STATE OF NEW MEXICO

HOMESTAKE MINING COMPANY

RE: SUA-708 Homestake Mining Company - Grants Operation

This letter is written in response to those questions presented by your contractors on May 5, 1983 (Dr. Schreiber) and May 19, 1983 (Stephen Wells).

HOMESTAKE MINING COMPANY — GRANT'S PRECIPITATION FREQUENCY RELATIONSHIP

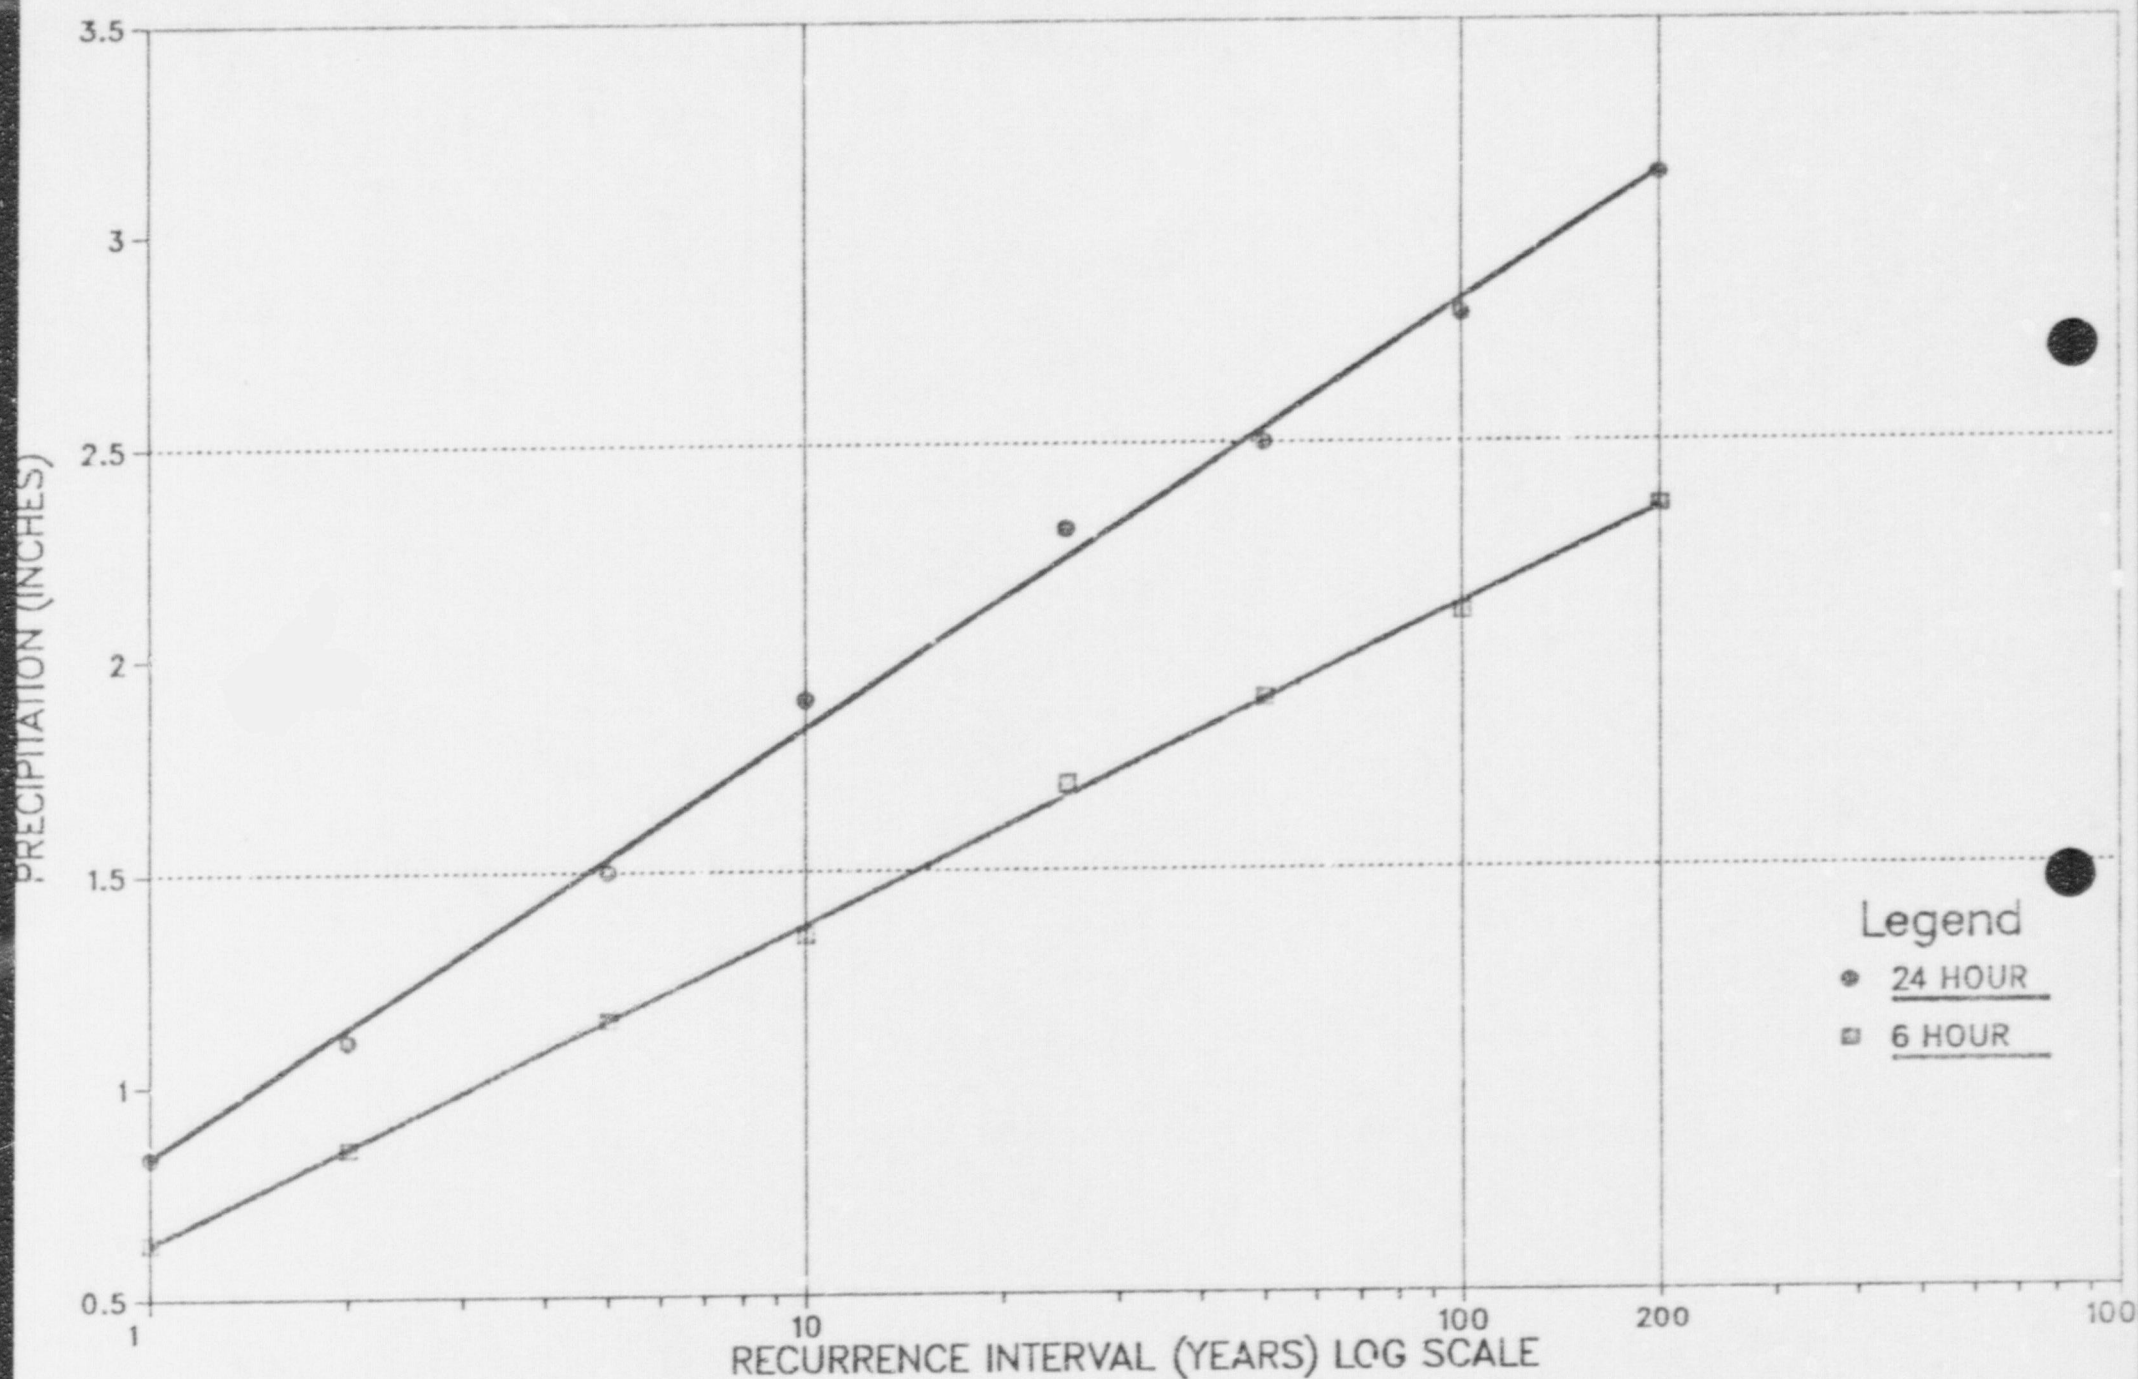
4. Section C9.3.6, p. C9-9, paragraph 1. The extrapolated graph of the 6-hour and 24-hour rainfall data should be provided for review, as well as the adjustments made for areal corrections.

The extrapolated graph for 6-hour and 24-hour rainfall data and adjustments made for areal corrections are attached (Attachment 1).

To determine the 200-year, 6 and 24-hour storms the precipitation frequency relationships for the 2 thru 100-year storms were plotted on semi-log paper and the relationship extended to 200-years. The 2-100 year storm amounts were obtained from the National Oceanic and Atmospheric Administration Precipitation-Frequency Atlas for New Mexico.

The area reduction factors for 291 square miles are 0.839 and 0.916 for 6 and 24-hour storms, respectively.

These precipitation amounts were used in THYDB to compute the 200-year peak discharges. The peak discharge of 8456 cfs was used in the HEC-2 program.
